CITY OF ALBUQUERQUE

RE: **McDonalds – Menaul and San Pedro**
5900 Menaul Blvd NE
Site Plan for Building Permit
(Non-stamped) Plan Date: 8/9/18 (File: H18D070)

RE: McDonald's 5900 Menaul Blvd NE – HYDROLOGY COMMENTS

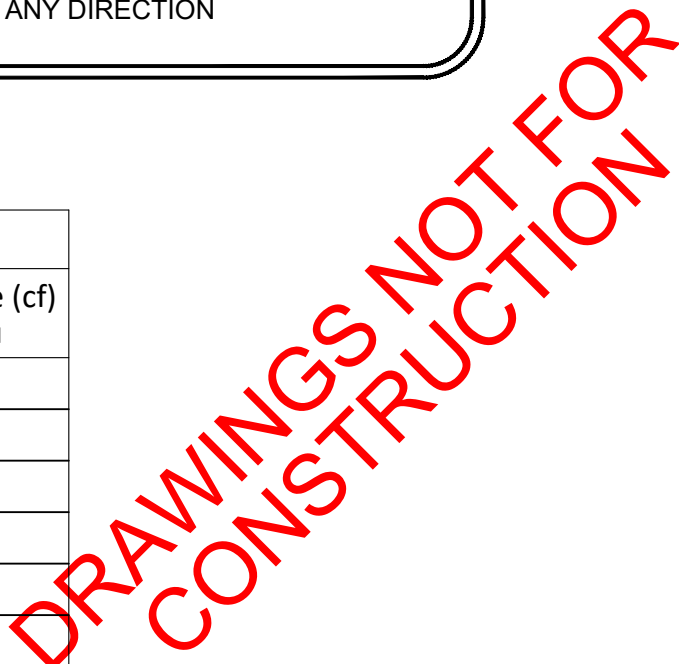
Building Permit Comments:

This submittal is only for conceptual approval and full building permit comments will be addressed during the building permit process.
